City of Mississauga

Corporate Report

PUBLIC MEETING RECOMMENDATION REPORT (WARD 2)

Official Plan and Zoning By-law Amendment applications to permit 180, three storey, back to back townhouses in 12 development blocks

Proposed Concept Plan

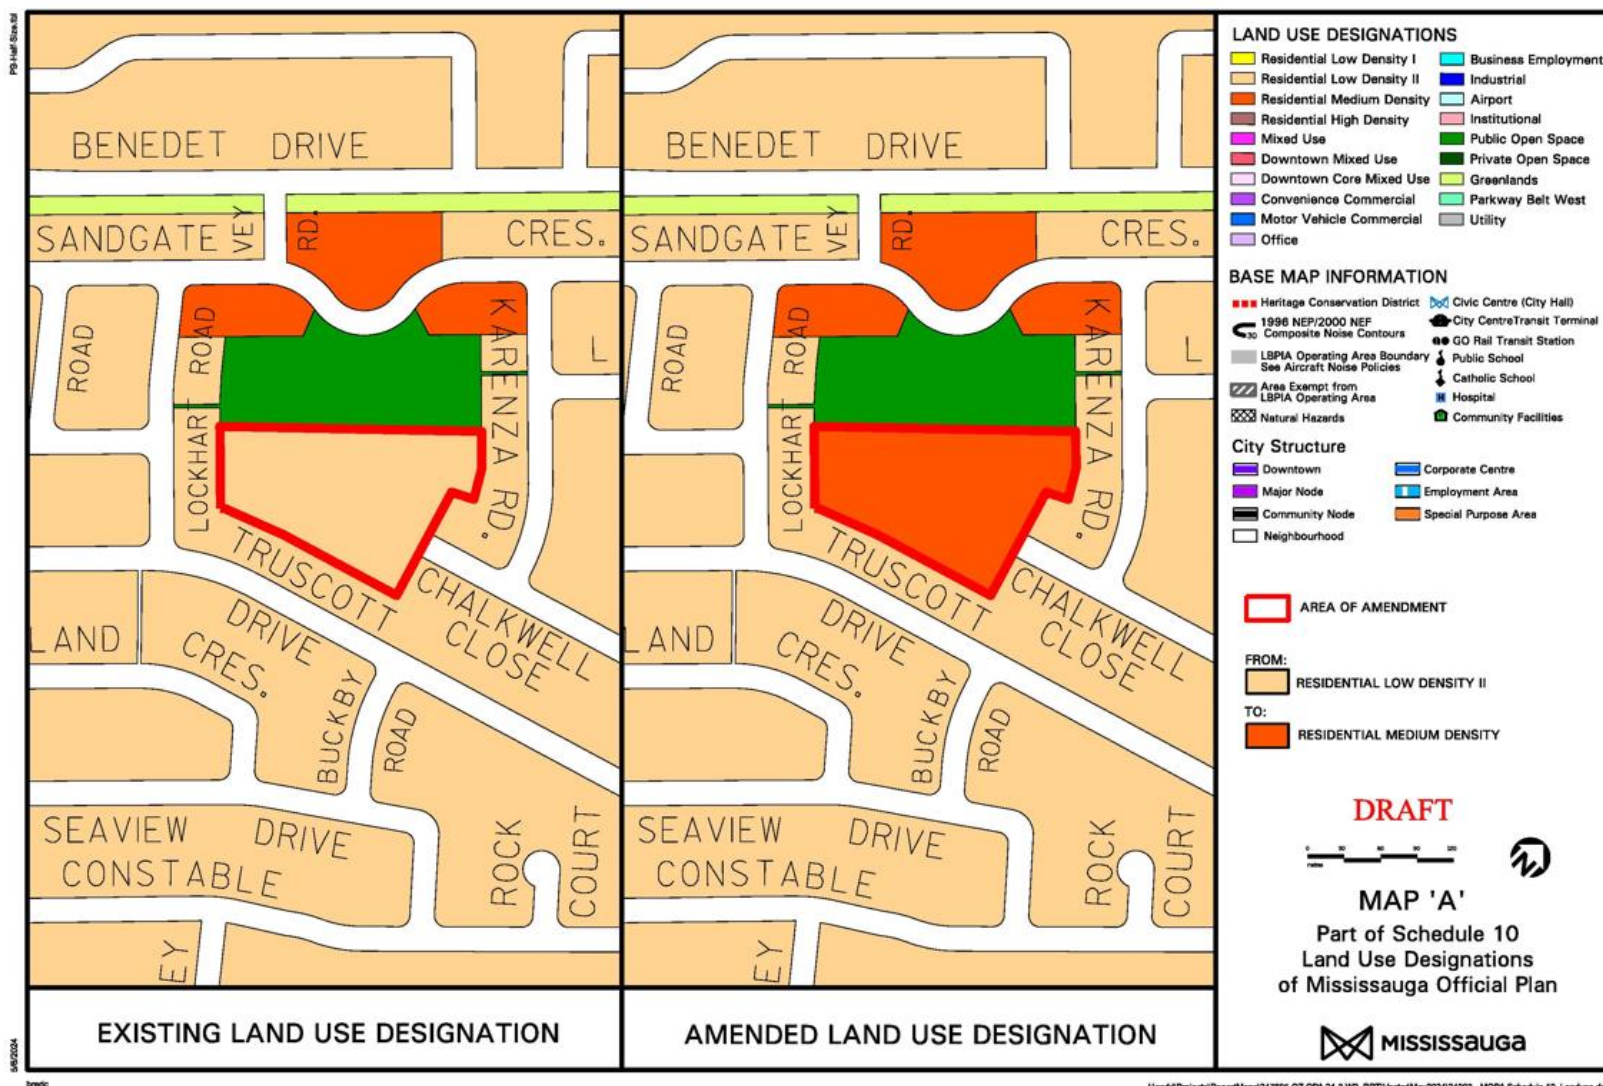
- Omitted information on the concept plan including: transformer locations, community mailboxes, light poles, fire hydrants and sufficient waste collection locations;

- No pedestrian connection from the proposed development with the existing walkway to Truscott Drive;
- Inappropriate vehicular turning facility at the terminus of Chalkwell Close;

- Waste collection plan that is inconsistent with Region of Peel standards;
- Obstructed fire access route for Blocks A, B, C, D, E, F G, and H and inappropriate turning locations for fire and emergency vehicles throughout the site;

- A single emergency access to the property where 2 emergency accesses are required for developments with a total dwelling count greater than 100 units;

- Unauthorized encroachments into the Alectra easement;
- Storm drainage run-off that negatively impacts Sandgate Park; and,
- Site design aspects that are not consistent with Crime Prevention Through Environmental Design criteria.
